$\frac{1}{2}$ " MARKAB
 REMOVING OF W.T. BULKHEAD N° 75 AND
 N.W.T. BULKHEAD N° 68 TO BE MADE WATERTIGHT.
 Scale: $\frac{1}{4}$ "=1'0" $\frac{1}{2}$ "=1'0"

PI. n° 5566-20-2

MERCANTILE M.E. & G.D.C. Antwerp 1-7-49

Removing of W.T. bulkhead No 75 and
N.W.T. Bulkhead No. 68. to be made
watertight.

W.T. BULKHEAD FR 68
 Looking aft.

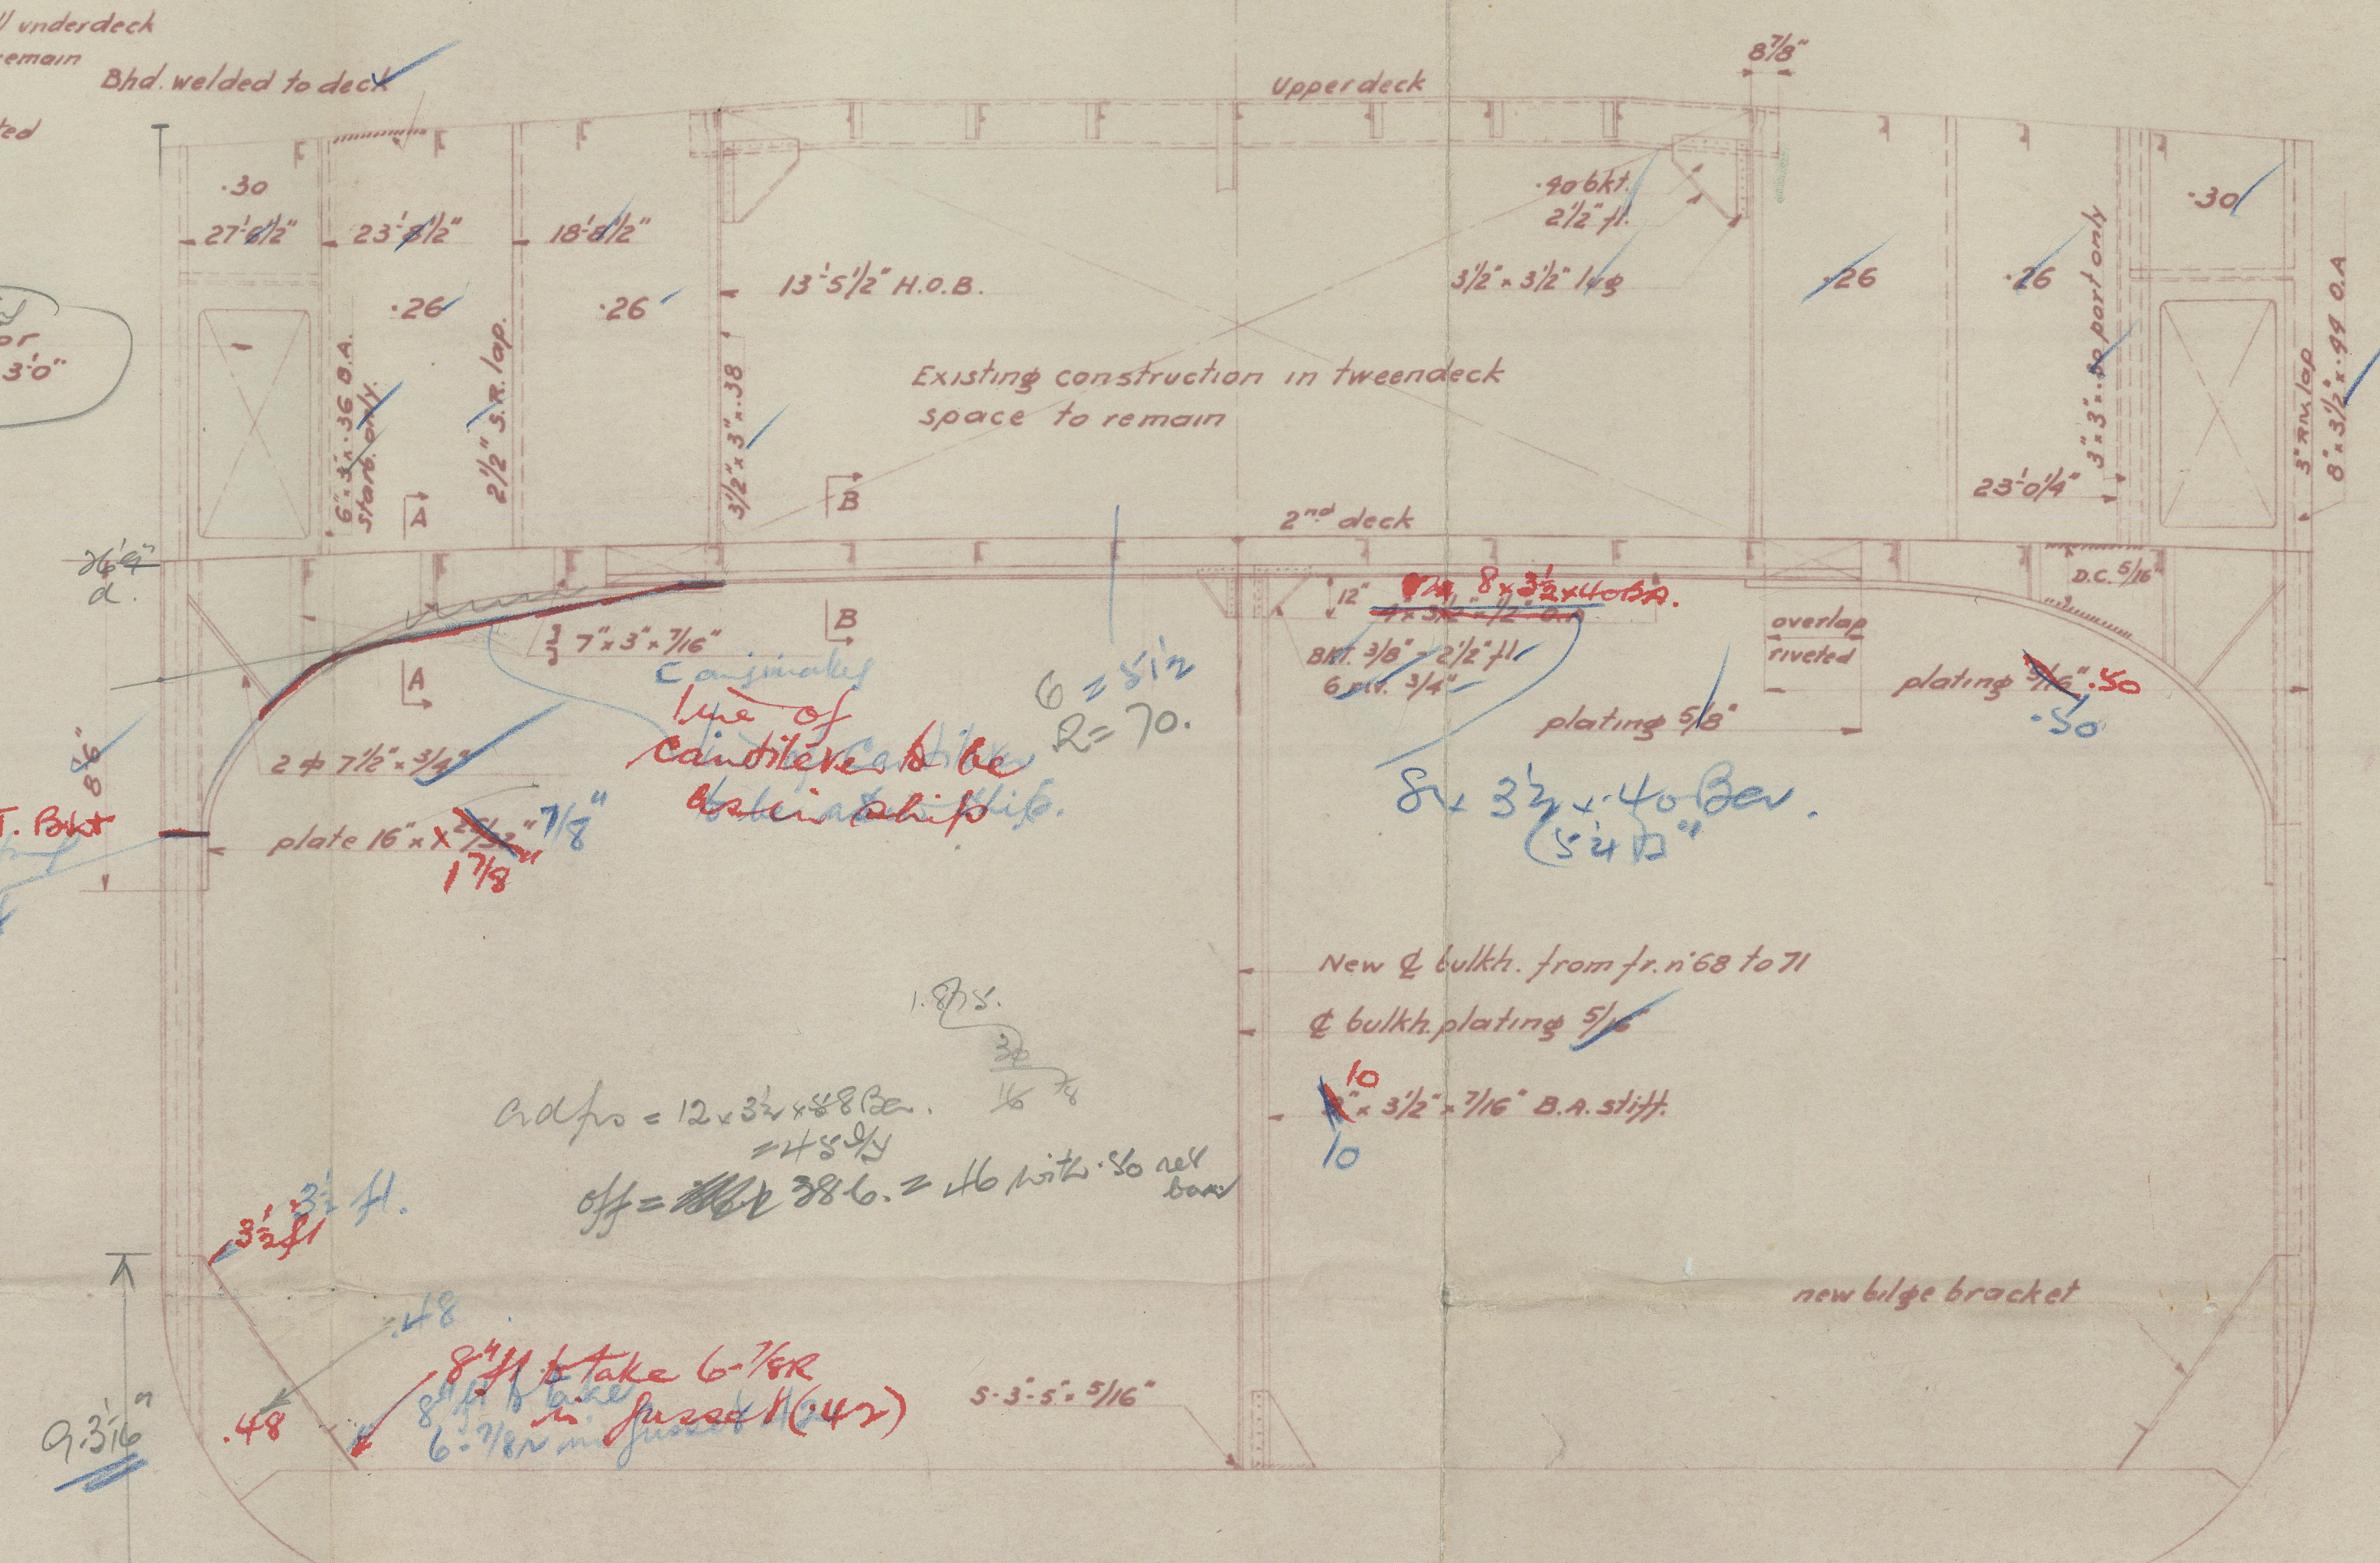
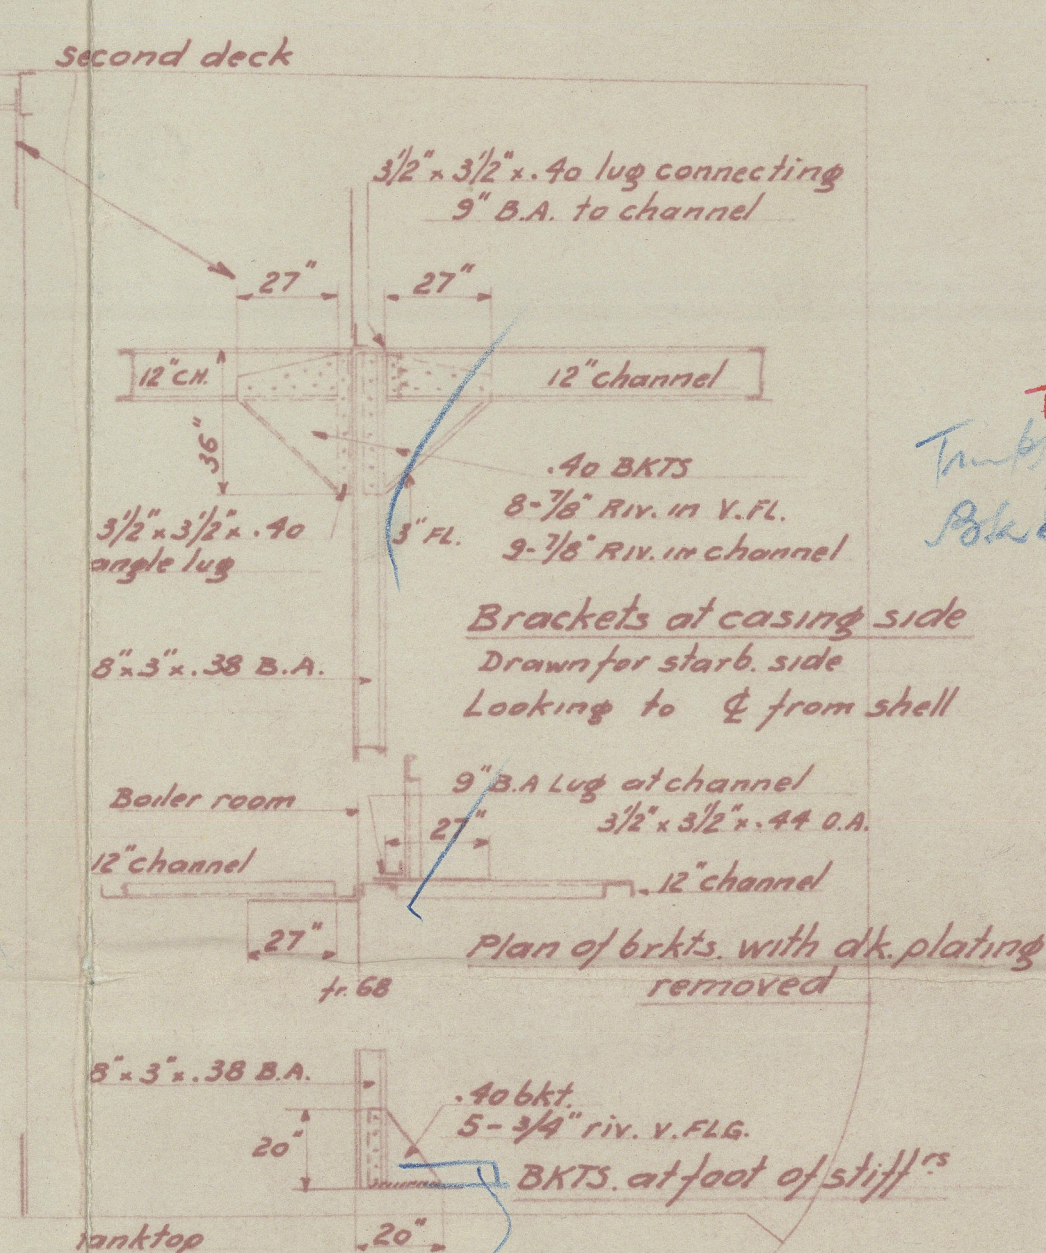
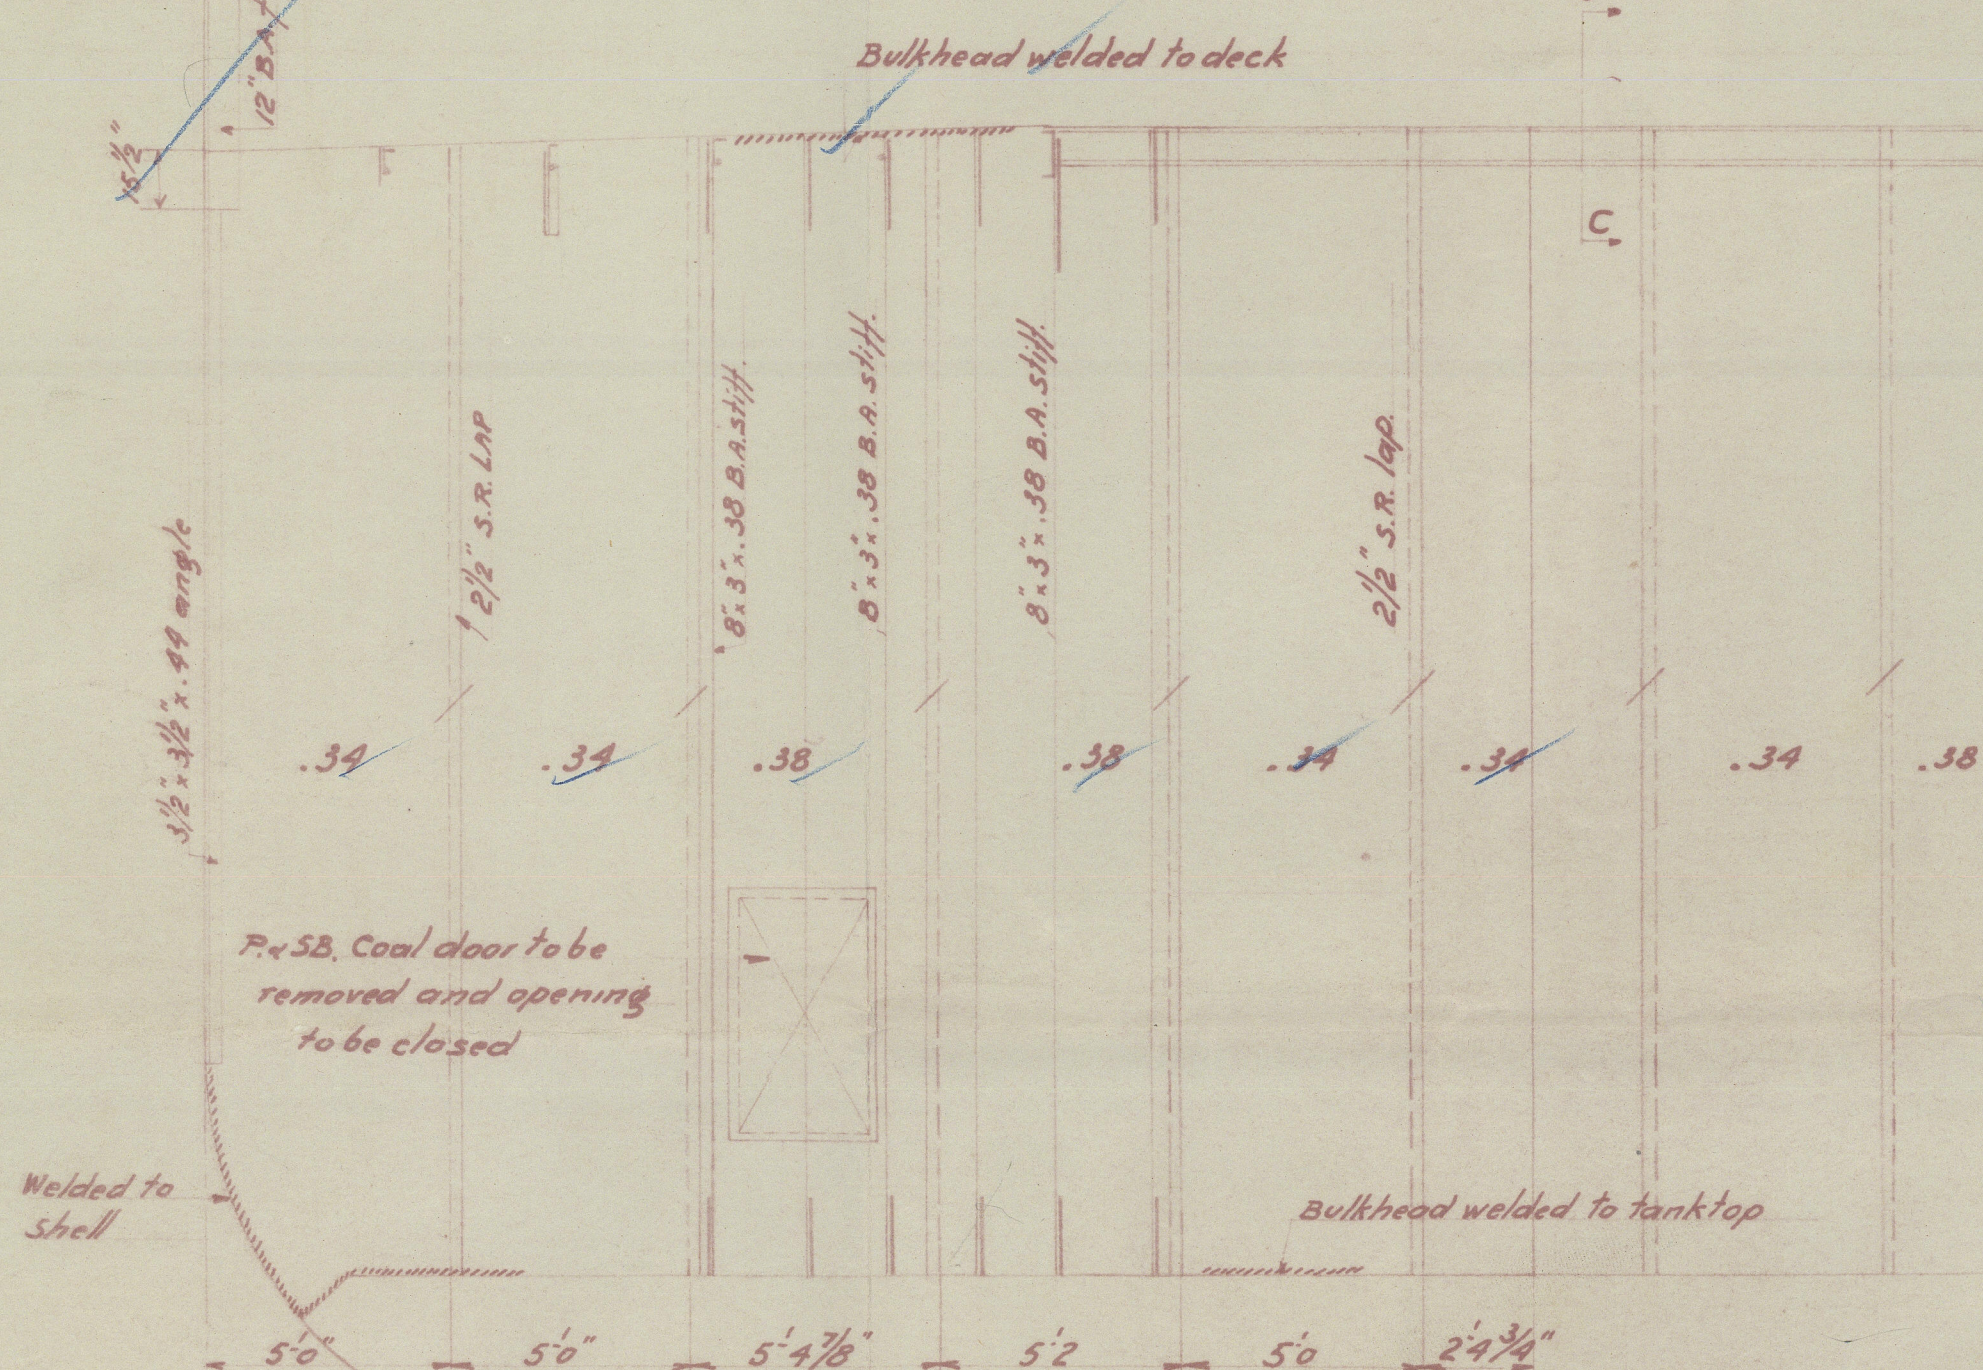
Hatch coaming angle on deck to be removed. All underdeck girders and supports around hatch opening to remain
 Twendeck hatch to be closed
 Additional longitudinal beams to be fitted
 Similar to existing ones

Detail of extra vertical stiffeners on bhd. 68. Port & Starb.
